UNITED STATES PATENT AND TRADEMARK OFFICE

Advisory Action Before the Filing of an Appeal Brief	Application No. 10/707,136	Applicant(s) WESLING, KEVIN	
	Examiner Lee Lum	Art Unit 3611

Addendum to Advisory Action

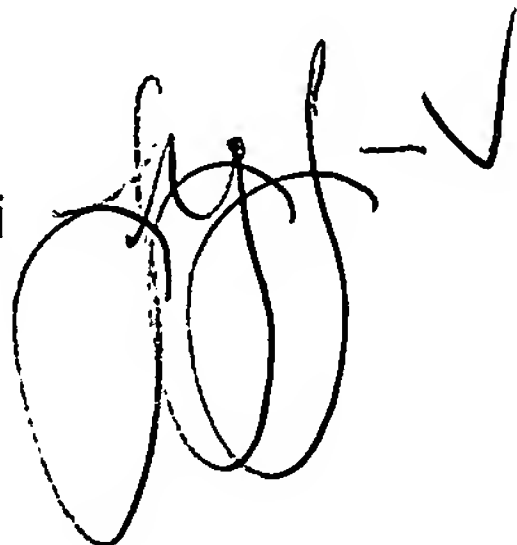
Applicant's arguments have been considered but are nonpersuasive.

As discussed in the previous Office Action mailed 1/26/06, Kuo discloses all recited elements, including "a housing integrally formed with the crown", as clearly depicted in fig 6. The housing comprises all elements adjacent the unidentified crown; 62,611-613,B.

Re the issue of the limitation "forged together", while this may be interpreted as "limitations on the structure of the invention", as Applicant suggests, it is also reasonable to consider it as referring to the manner in which the invention was made. In this manner, this issue was properly interpreted with respect to Kuo.

Therefore, the reference is maintained as proper because all recitations are disclosed.
